Basis of this breakdown

1. Bulletin 3 (M-529 / M-530 / M-531, revision 4, 08/10/2026) was issued after the ductwork in the affected areas had been fabricated and installed per the Addendum 1 drawings. The change therefore includes **disconnecting and removing installed ductwork**, in addition to fabricating and installing the revised work.

Snowflake Fitout - 7 Times Square, Floors 29-31 | COP-SF-05 Bulletin 3 Revision

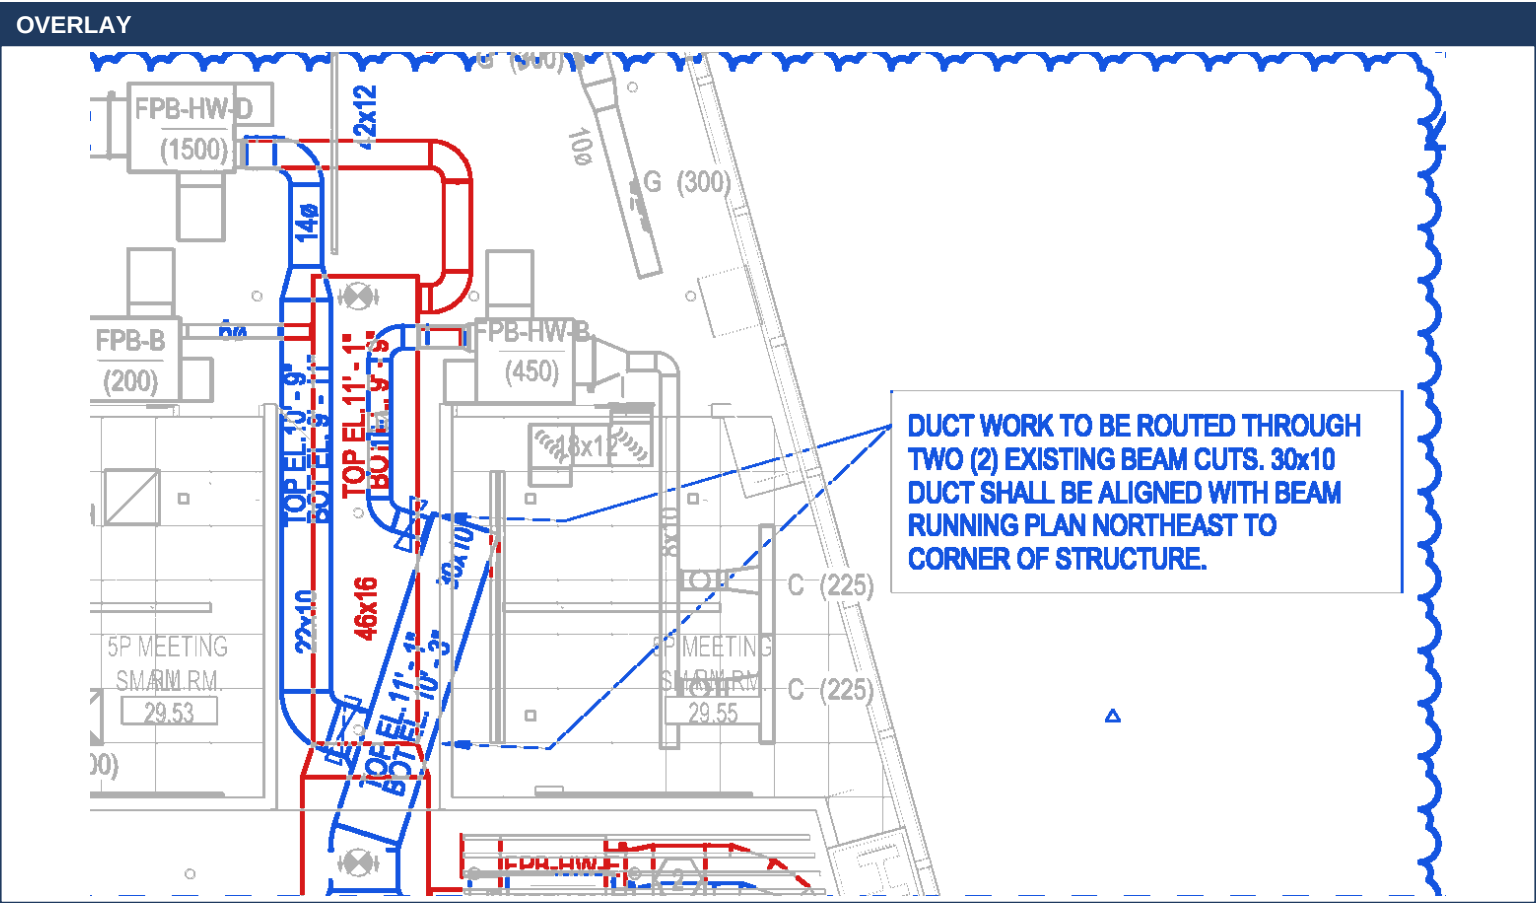
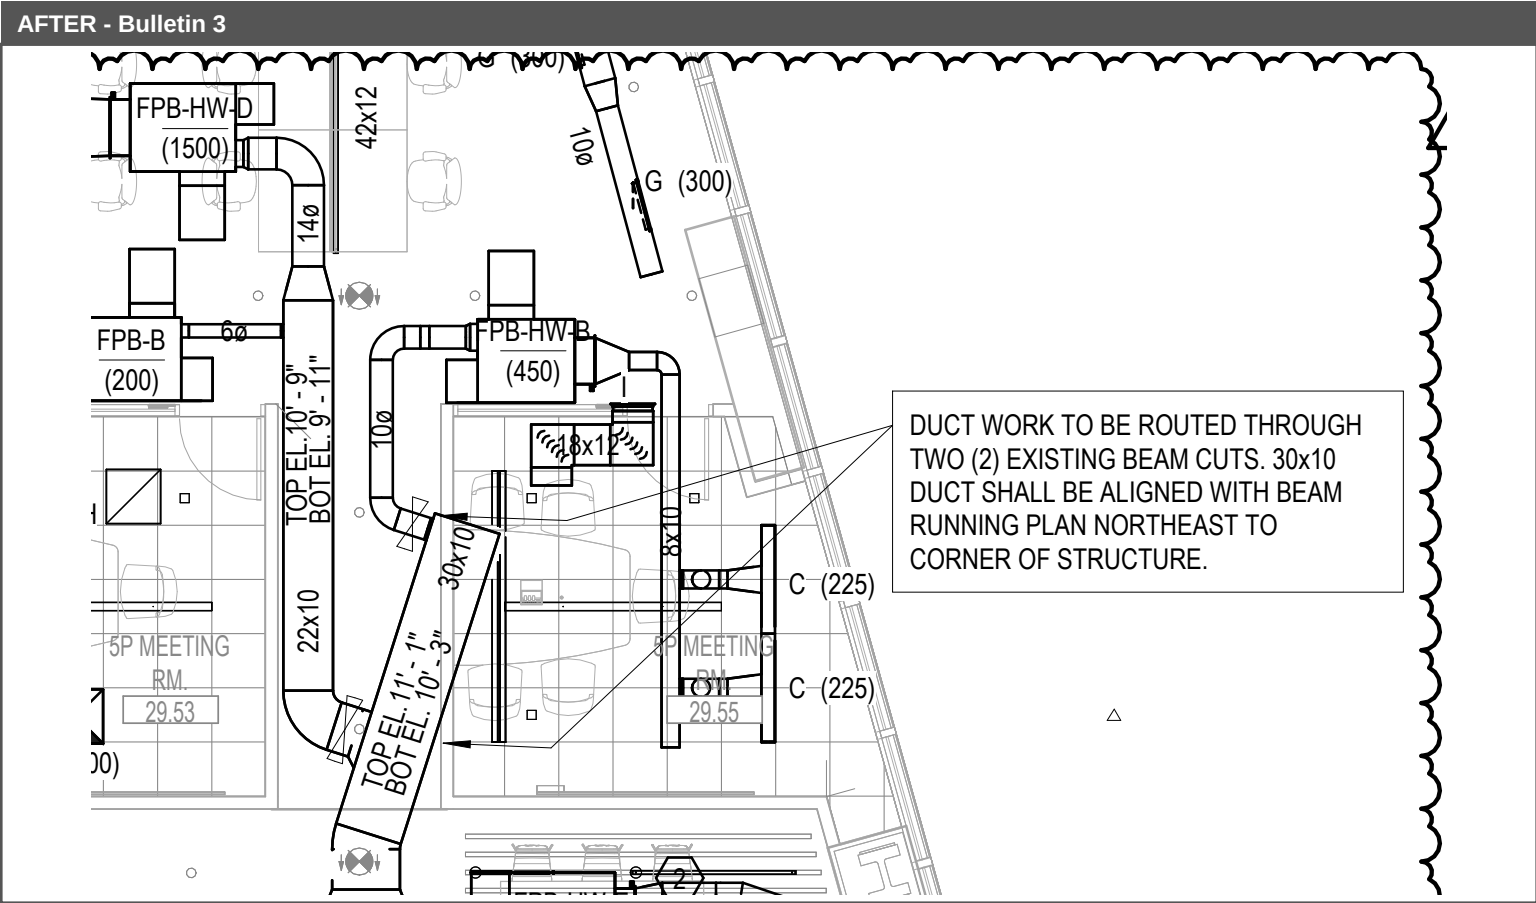
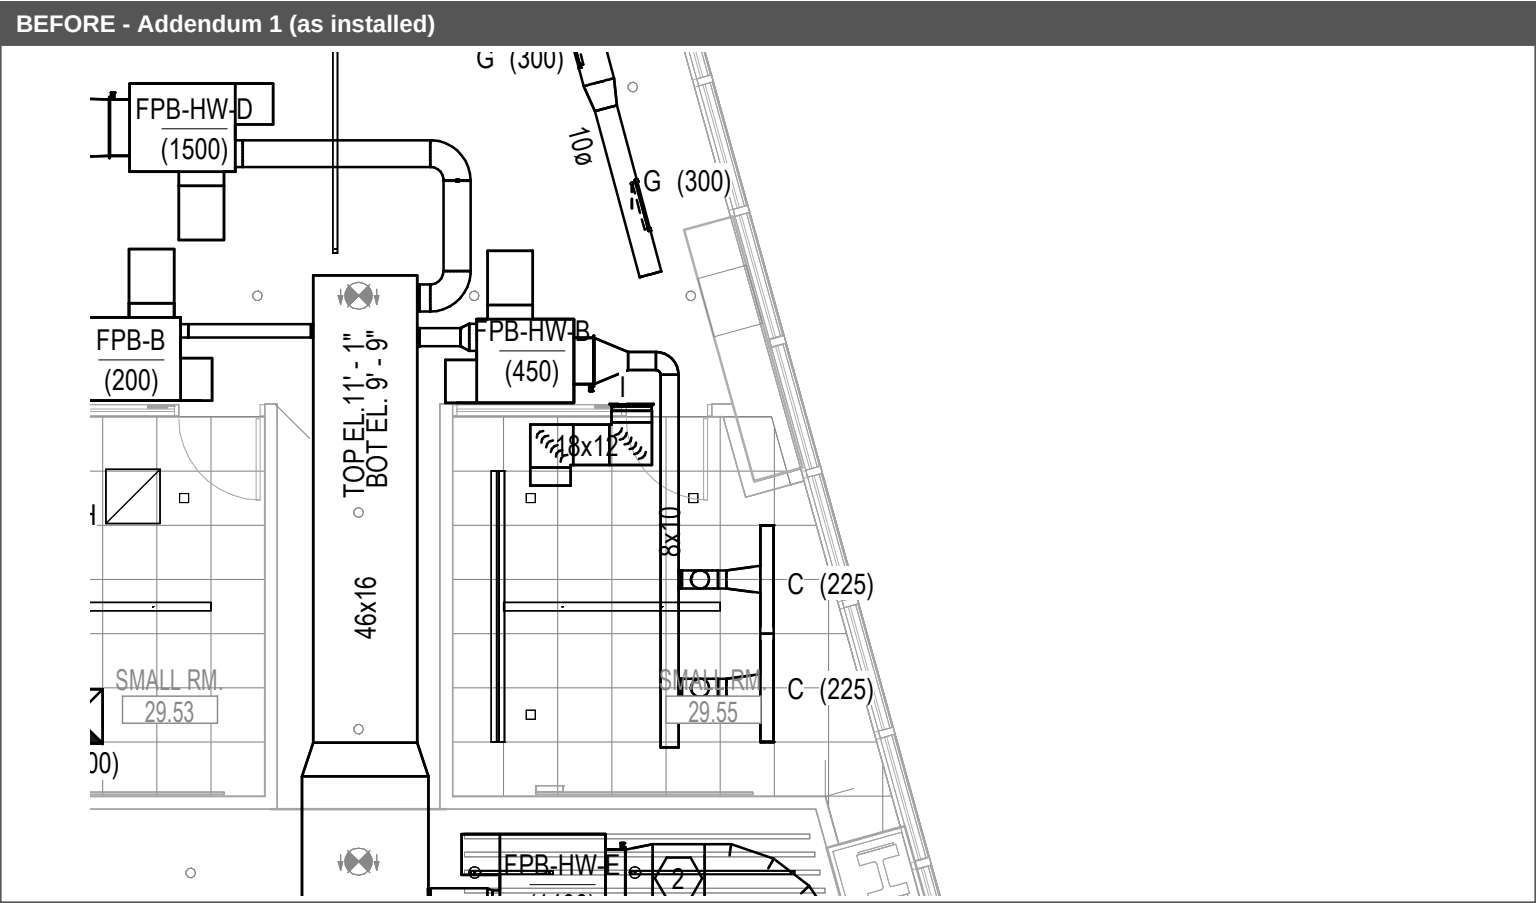
Before (Addendum 1, installed): 46x16 supply main (approx. 20 LF, bottom el. 9'-9") with branch connections to FPB-HW-D (1500), FPB-HW-B (450) and FPB-B (200).

After (Bulletin 3): Main rerouted as 22x10 and 30x10 through (2) existing beam cuts, 30x10 aligned with the beam running plan northeast. New 14ø branch to FPB-HW-D, 10ø to FPB-HW-B and 6ø to FPB-B.

Work required: Disconnect and remove installed 46x16 section and branch connections. Fabricate and install 22x10 / 30x10 duct and round branches with insulation, reconnect terminal units.

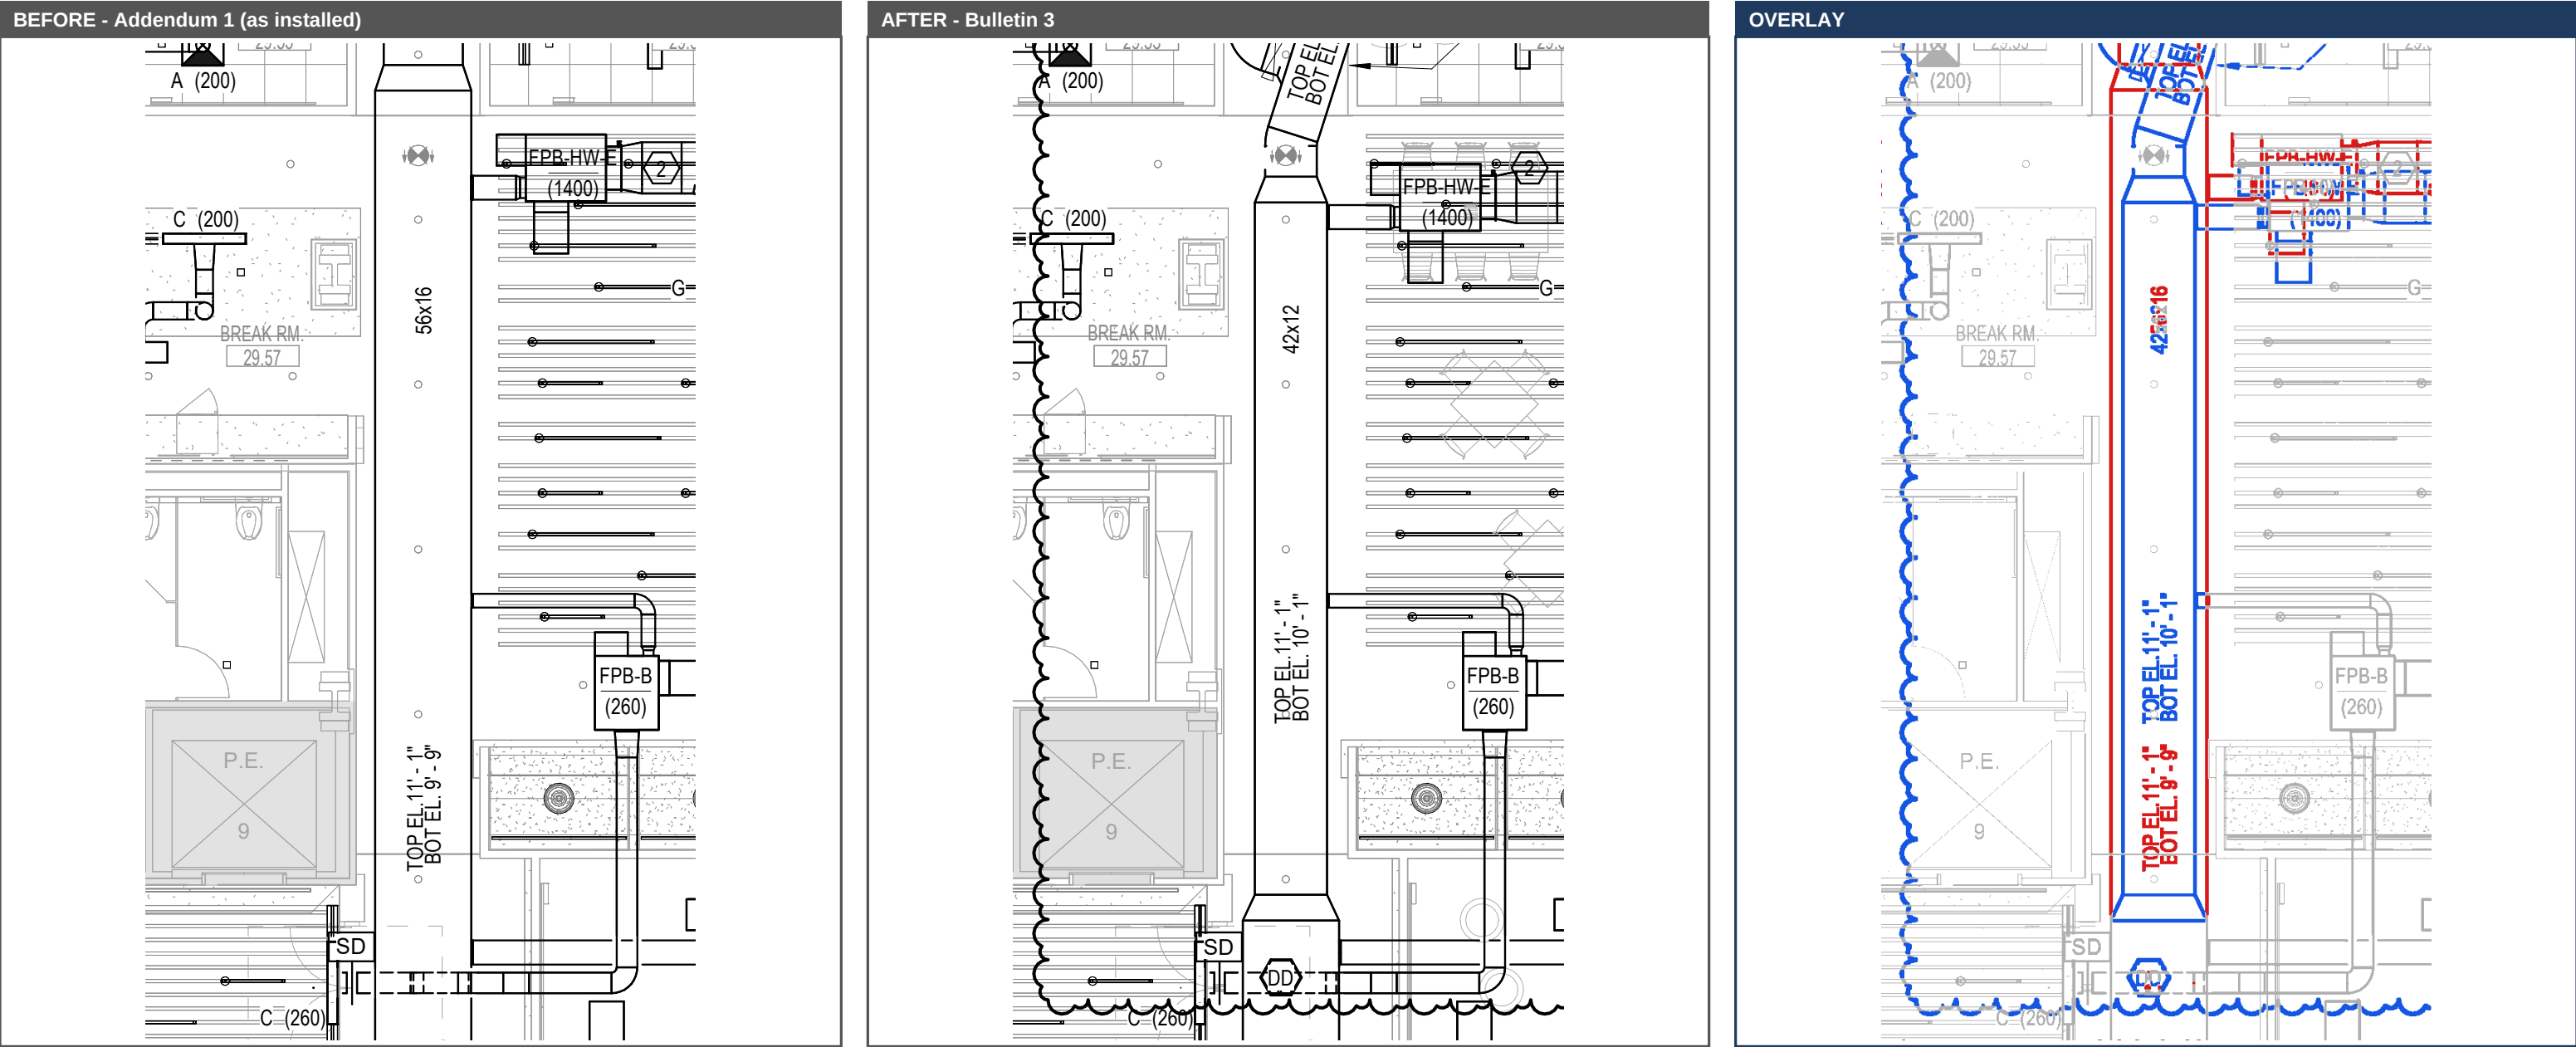
Before (Addendum 1, installed): 56x16 supply main, approx. 44 LF, top el. 11'-1" / bottom el. 9'-9", Break Rm 29.57 to P.E.

After (Bulletin 3): Main resized to 42x12 on the same route, top el. 11'-1" / bottom el. 10'-1".

Work required: Disconnect and remove installed 56x16 main. Fabricate and install 42x12 main with insulation, reconnect branch takeoffs (FPB-HW-E, FPB-B (260)).

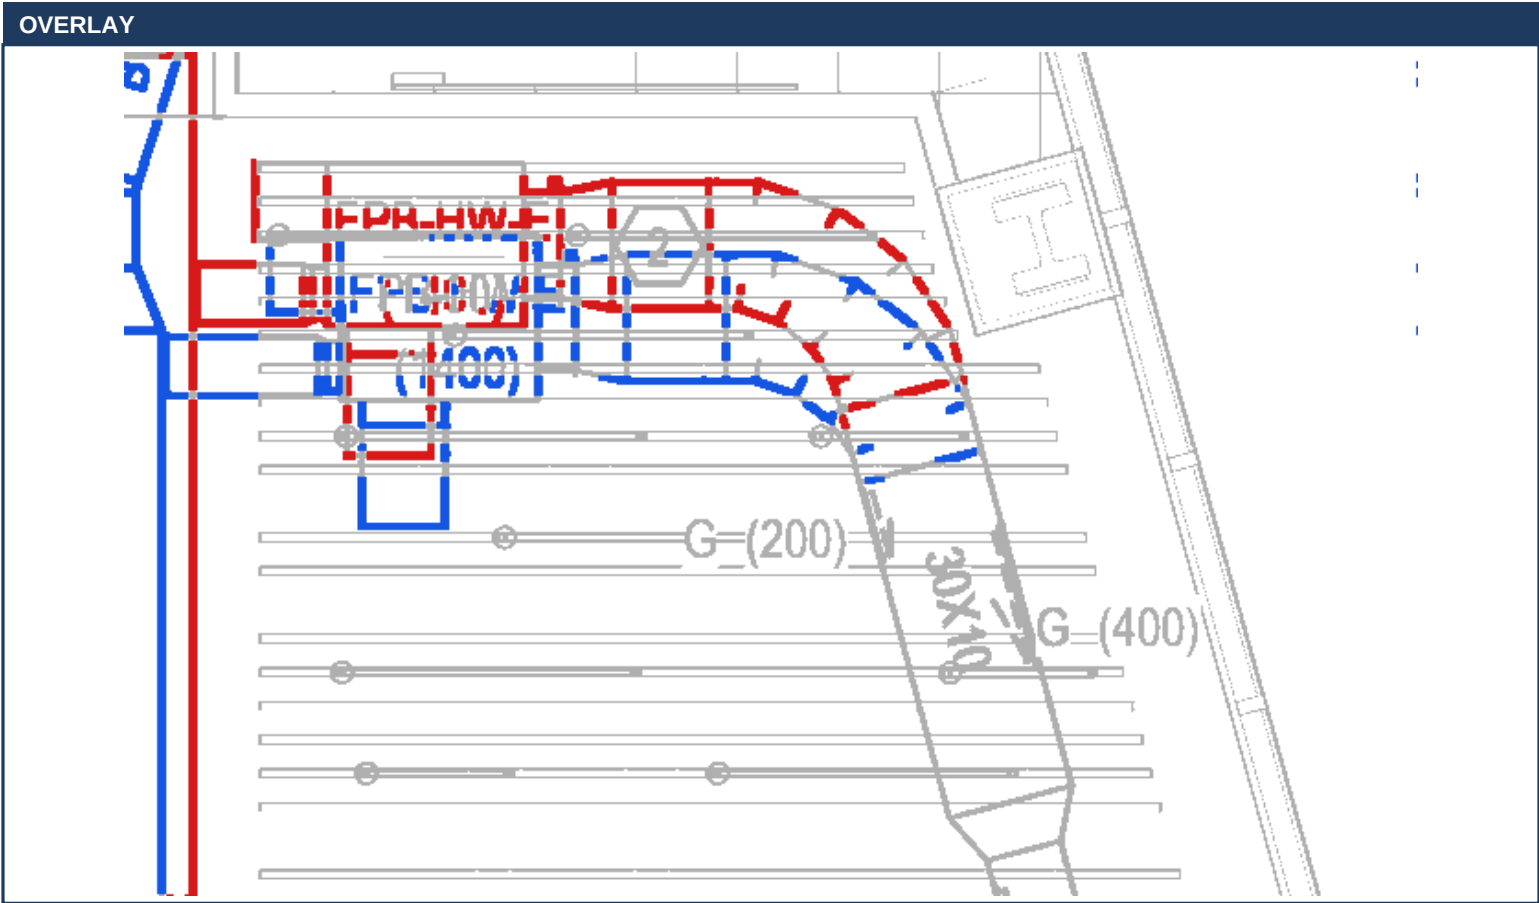
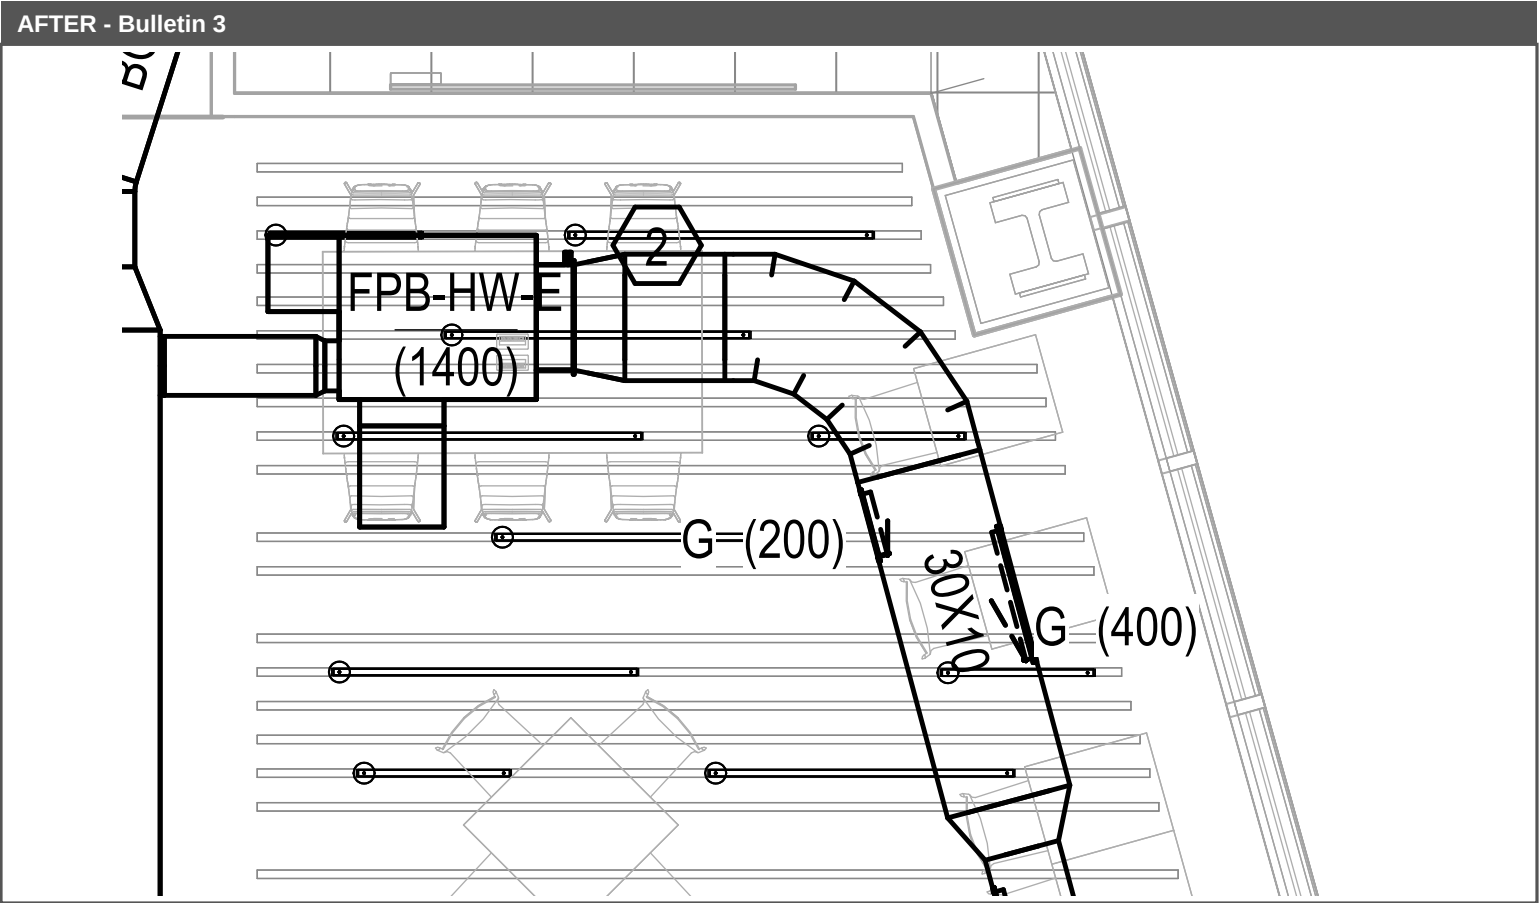
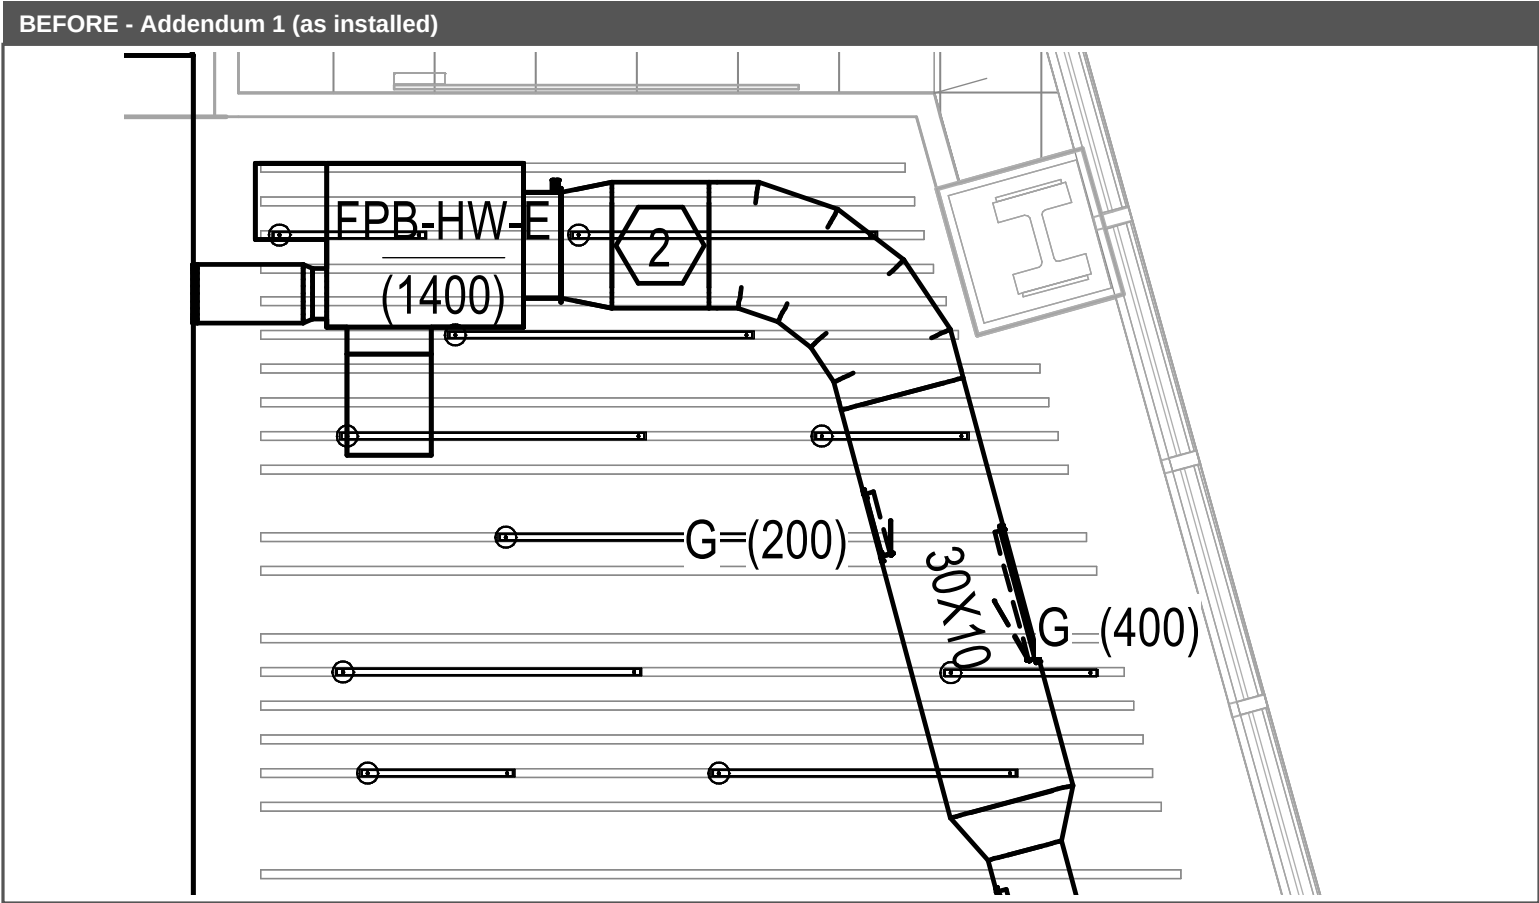
Before (Addendum 1, installed): FPB-HW-E (1400) with inlet and 30x10 discharge to the G(400) / G(200) linear diffusers along the northeast wall.

After (Bulletin 3): FPB-HW-E relocated; inlet connection and 30x10 discharge elbow rerouted.

Work required: Disconnect inlet and discharge, relocate and rehang FPB-HW-E, fabricate and install new inlet and 30x10 discharge fittings, reconnect.
